UNITED STATES
DEPARTMENT OF THE INTERIOR
BUREAU OF LAND MANAGEMENT
APPLICATION FOR PERMIT TO DRILL OR REENTER

1a. Type of work: <input checked="" type="checkbox"/> DRILL <input type="checkbox"/> REENTER 1b. Type of Well: <input checked="" type="checkbox"/> Oil Well <input type="checkbox"/> Gas Well <input type="checkbox"/> Other 1c. Type of Completion: <input type="checkbox"/> Hydraulic Fracturing <input checked="" type="checkbox"/> Single Zone <input type="checkbox"/> Multiple Zone		5. Lease Serial No. NMNM102917 6. If Indian, Allottee or Tribe Name 7. If Unit or CA Agreement, Name and No. 8. Lease Name and Well No. CASEY JONES 21 FED COM 723H 9. API Well No. 30-015-54131

PECOS DISTRICT DRILLING CONDITIONS OF APPROVAL

OPERATOR'S NAME:	EOG RESOURCES INCORPORATED
WELL NAME & NO.:	CASEY JONES 21 FED COM 723H
SURFACE HOLE FOOTAGE:	2555'/S & 570'/E
BOTTOM HOLE FOOTAGE:	230'/N & 990'/E
LOCATION:	Section 21, T.26 S., R.30 E., NMP
COUNTY:	Eddy County, New Mexico

Proposed Wellbore

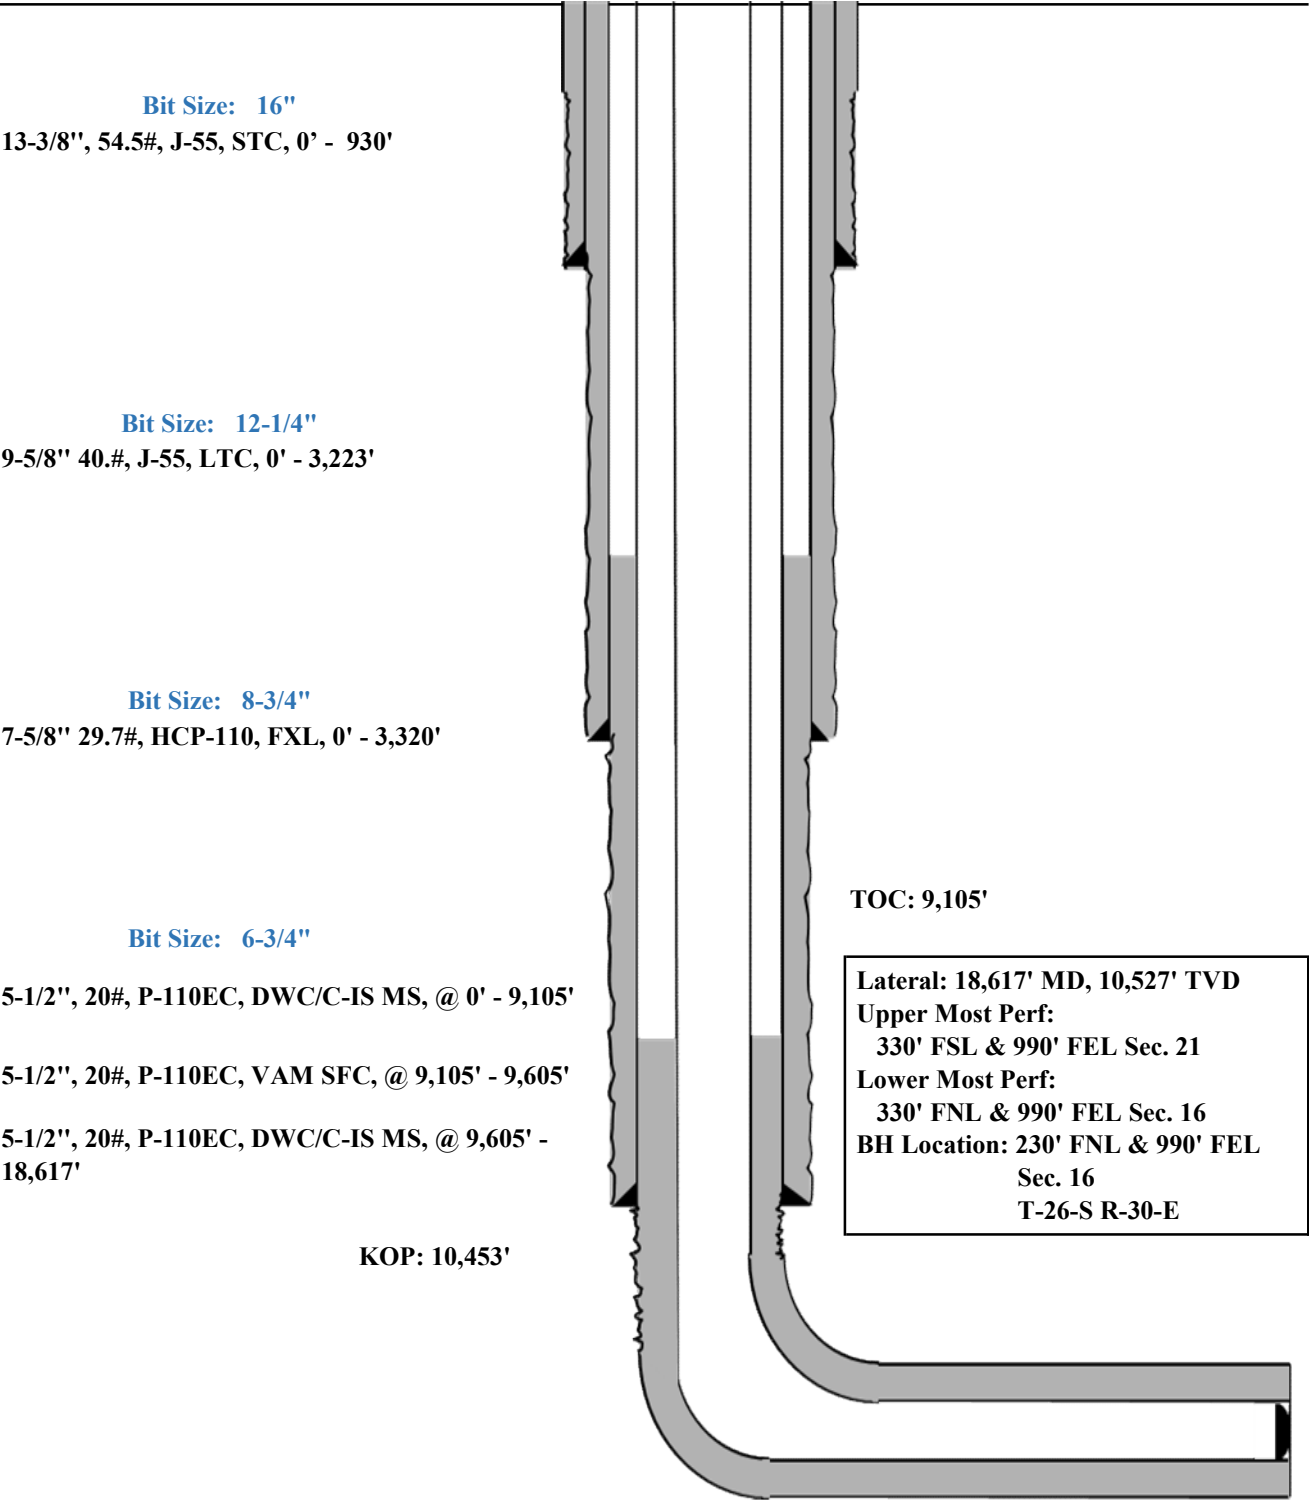
Operator is only approved for Design A. Design B is not to be utilized. If Design B is needed or any other change, please submit a NOI sundry to make the changes.
